Access Compliance Report

Public Rights-of-Way

(Curb Ramps)

Intersection ID: 29238	Main Street: POINTER RIDGE DR	Cross Street: WOODINGTON LN	Location: S
ADA ID: C139563FD6F0	Ramp Type: PerpDiag	Initial Pass/Fail: Fail	Overall Compliance: No
Codes/Mitigation Info/Possible Solution		Field Measurements/Component Compliance

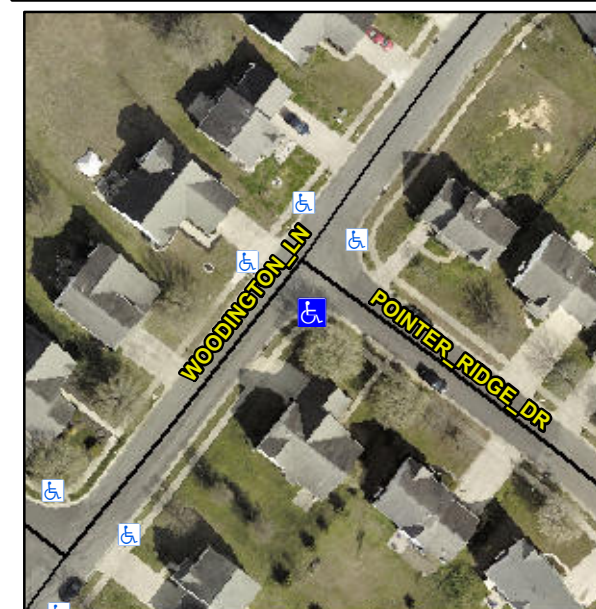
Not Found, R304.5.1, R304.5.3

Compliance	Description	Data	Compliance	Description	Data
N/A	Ramp Length (in)	49.0	Yes	Ramp Slope (%)	7.3
No	Ramp Width (in)	41.0	No	Ramp XSlope (%)	3.7
N/A	Flare Type LT	N/A	N/A	Flare Type RT	N/A
N/A	Flare Slope LT (%)	N/A	N/A	Flare Slope RT (%)	N/A
N/A	Flare Traversable LT?	N/A	N/A	Flare Traversable RT?	N/A
N/A	Landing Length (in)	N/A	N/A	DWS Provided?	N/A
N/A	Landing Width (in)	N/A	N/A	DWS Contrast?	N/A
N/A	Landing Slope (%)	N/A	N/A	DWS Length (in)	N/A
N/A	Landing X Slope (%)	N/A	N/A	DWS Full Width?	N/A
N/A	Landing Curb? (Y/N)	N/A	N/A	DWS Offset (in)	N/A
N/A	Shared Landing?	N/A			
N/A	Gutter Ponding?	N/A	N/A	Gutter Slope (%)	N/A
N/A	Gutter Lip Ht (in)	N/A	N/A	Gutter X Slope (%)	N/A
N/A	Painted X Walk1?	No	N/A	Painted X Walk2?	No
	X Walk 1 Direction	To NE		X Walk 2 Direction	To NW
N/A	X Walk 1 Width (in)	N/A	N/A	X Walk 2 Width (in)	N/A
	X Walk 1 Slope (%)	7.7		X Walk 2 Slope (%)	5.5
	X Walk 1 X Slope (%)	2.9		X Walk 2 X Slope (%)	6.9

Remove & Replace Curb Ramp With Two New Directional Ramps or Equivalent.
